HN-215.2\*  
DN-156.2\*  
EN-46.2\*  
FN-34.2\*  
NN-010

# SERVICE BULLETIN

DATE: 11 APRIL 1997  
PAGE 1 OF 4

## OVERRUNNING CLUTCH OUTER RACE INSPECTION

Figure 1. Inspection of Overrunning Clutch Assembly Outer Race.

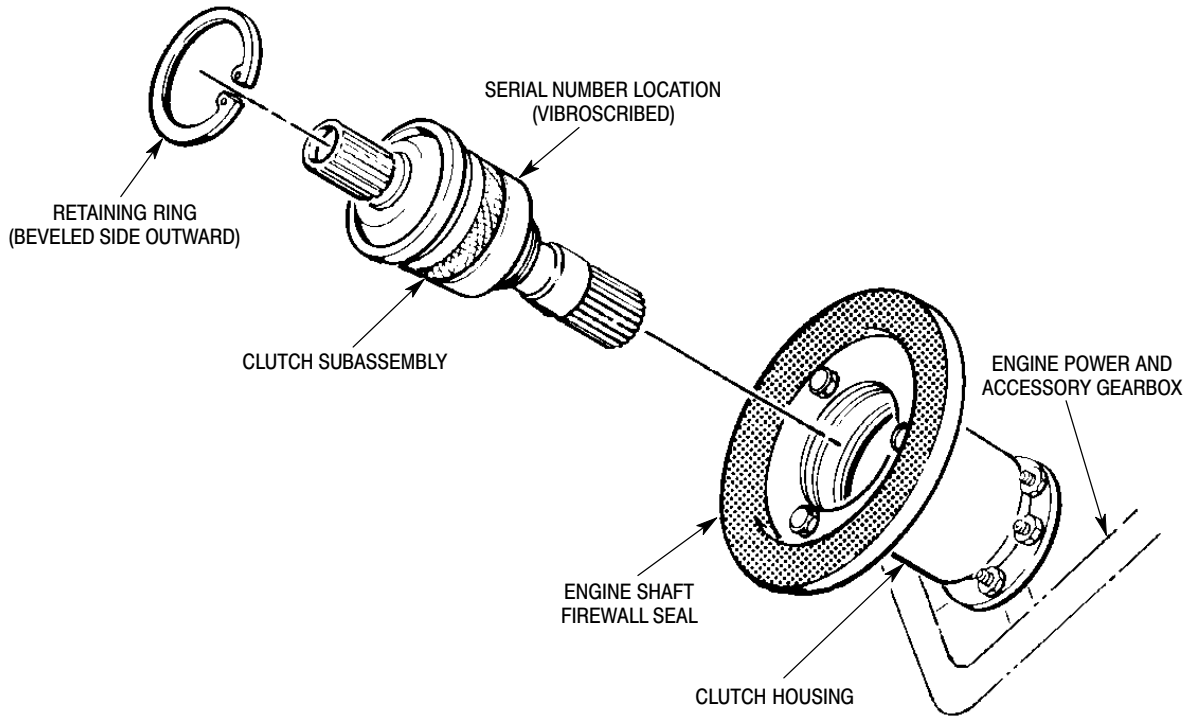
C. Inspect outer race and record serial number of outer race in Log Book.

Serial numbers are clearly vibroscribed on outer surface of the outer race on affected parts. (See Figure 1.)

D. If the outer race serial number is not 0692 thru 0927, proceed to step F. If the outer race serial number is 0692 thru 0927, proceed to step E.
